SUBJECT: WilMarc Medical Transportation Impact Study Addendum
(File: 1611ME01)

This memorandum serves as an addendum to the "WilMarc Medical Transportation Impact Study" (WMMTIS) dated October 2016. It addresses City staff comments with regard to signalization of the Harmony/Technology-HP intersection.

Figure 9

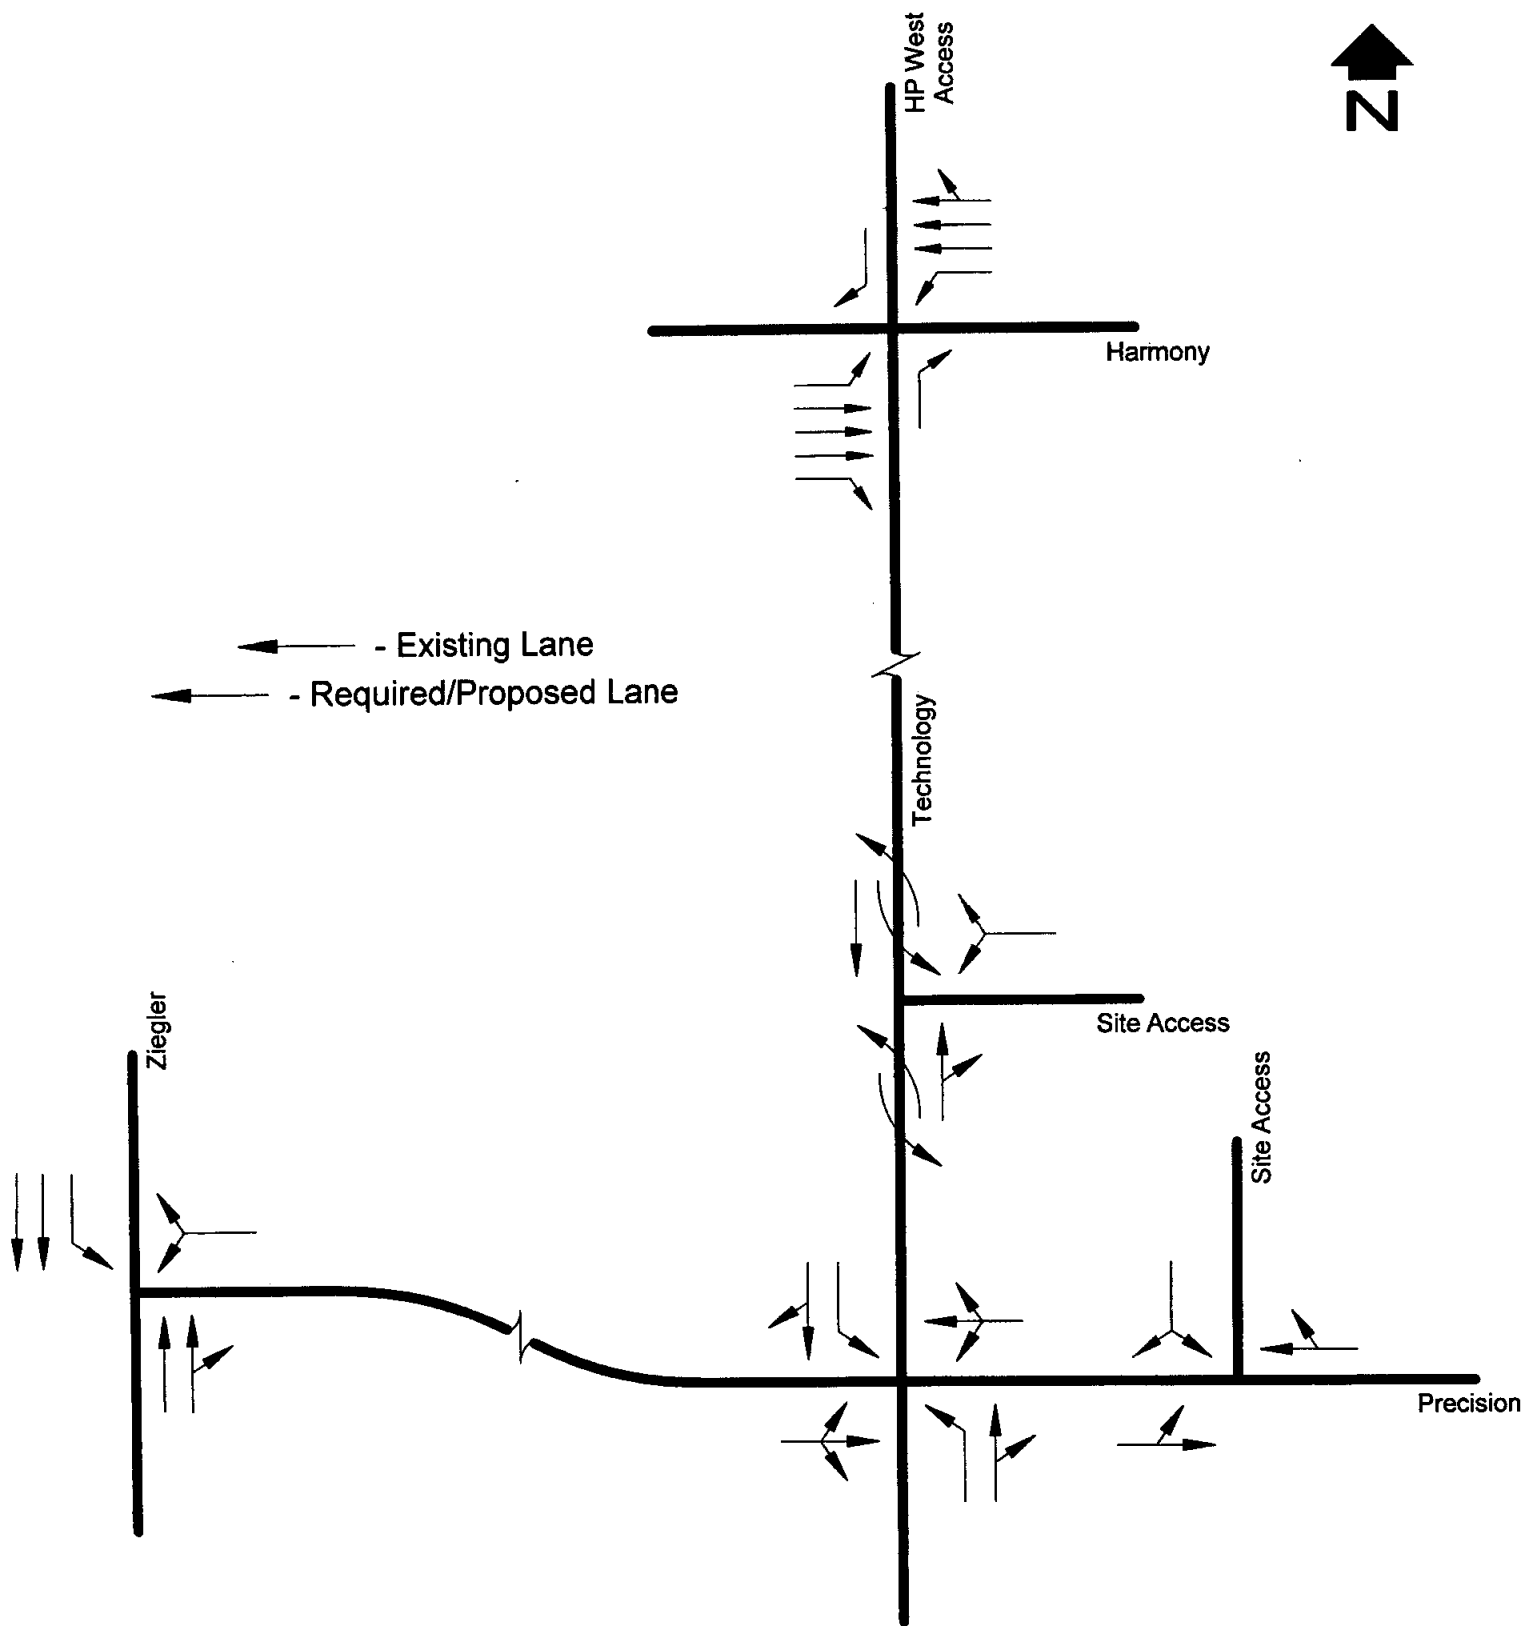
Therefore, it is concluded that the WilMarc Medical development does not require, nor will it pursue, signalization of the Harmony/Technology-HP intersection. It can move forward in the Fort Collins development review process without signalization at the Harmony/Technology-HP intersection. A revision of the 'CONCLUSIONS' page of the WMMTIS and the 'Figure 9, Short Range (2021) Geometry' page are attached.

- The short range (2021) geometry is shown in Figure 9. The Harmony/Technology-HP intersection is shown with right-in/right-out/left-in movements.
- Acceptable level of service is achieved for pedestrian, bicycle, and transit modes based upon the measures in the multi-modal transportation guidelines and future improvements to the street system in the area.
